CEN/TC 98/WG 3 N0007

Template for comments and secretariat observations

Date: 2015-10-27	Document: EN 1493:2010	Project: Revision
------------------	------------------------	-------------------

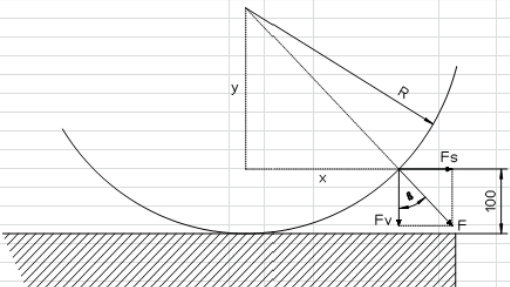
No.	MB/ NC ¹	Clause/ Subclause (e.g. 3.1)	Paragraph/ Figure/ Table/ (e.g. Table 1)	Type of comment ²	Comments	Proposed change	Observations of the secretariat
					<p>2) Steril made new calculations (see Excel file), differentiated for the first 6 normative vehicles (a through f). These normative vehicles have different wheelbases, which, in combination with vehicle lifts with suitable runway lengths, results in different free distances that allow a vehicle to develop speed. This effect is limited with normative vehicles g through l, because in most cases they just fit on a lift. Furthermore these vehicles have different wheel sizes, which give different angles at which the radial force is working. In the new calculations, also the rolling resistance is included, the stopping time is reduced from 1 second to the 0,8 second that Maha used in their calculation. This all results in total horizontal stopping forces from 8% to max 16% of rated capacity. Also a check is done on the height of the end stop: it should prevent the vehicle from driving over it. This is proven by the vertical resultant force that has to be smaller than the smallest axle load.</p> <p>3) The expression 'horizontal force' needs to be changed. Since this horizontal force is a <i>resultant</i> of the radial force, it never works without the, also resultant, vertical force (see calculation in Excel file). When designing end stops, these</p>

No.	MB/ NC ¹	Clause/ Subclause (e.g. 3.1)	Paragraph/ Figure/ Table/ (e.g. Table 1)	Type of comment ²	Comments	Proposed change	Observations of the secretariat																																																																																																																																																																																																																								
					forces are taken into account. Therefore the wording that is used to describe the load on the end stop should be changed as well.																																																																																																																																																																																																																										
<p>Stopping forces runway lifts</p>
